National Grid Company plc

Grid Code Review Panel

CC.6.3.3 Review Working Group

Figure 1

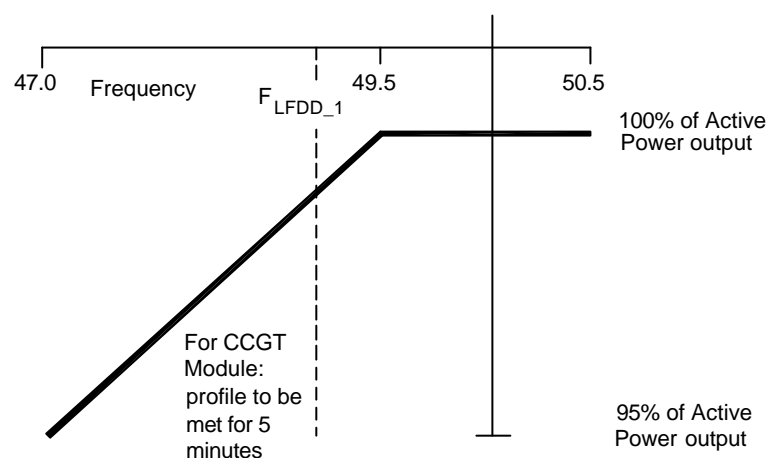
- 12 This paper proposes to amend the wording of CC.6.3.3 (b) to read as follows:-
 - CC.6.3.3 (b) maintaining its **Active Power** output at a level not lower than the figure determined by the linear relationship shown in Figure 1 for **System Frequency** changes within the range 49.5 to 47 Hz, such that if the **System Frequency** drops to 47 Hz the **Active Power** output does not decrease by more than 5%.

In the case of a **CCGT Module**, the above requirement shall be retained down to the low **Frequency** relay trip setting of 48.8Hz, or such other setting notified by **NGC** to the **User**, which will reflect the first stage of the Automatic Low **Frequency Demand Disconnection** scheme notified to **Network Operators** under OC6.6.2. For **System Frequency** below that setting, the existing requirement shall be retained for a period of 5 minutes while it remains below that setting, and special action(s) that may be required to meet this requirement shall be kept in service during this period. At the end of that 5 minutes period, if **System Frequency** remains below that setting, the special action(s) must be discontinued if there is a materially increased risk of the **Gas Turbine** tripping. The need for special action(s) is linked to the inherent **Gas Turbine Active Power** output reduction caused by reduced shaft speed due to falling **System Frequency**.

(Note: Frequency F_{LFDD_1} is the relay trip setting of the first stage of the Automatic Low **Frequency Demand Disconnection** scheme)
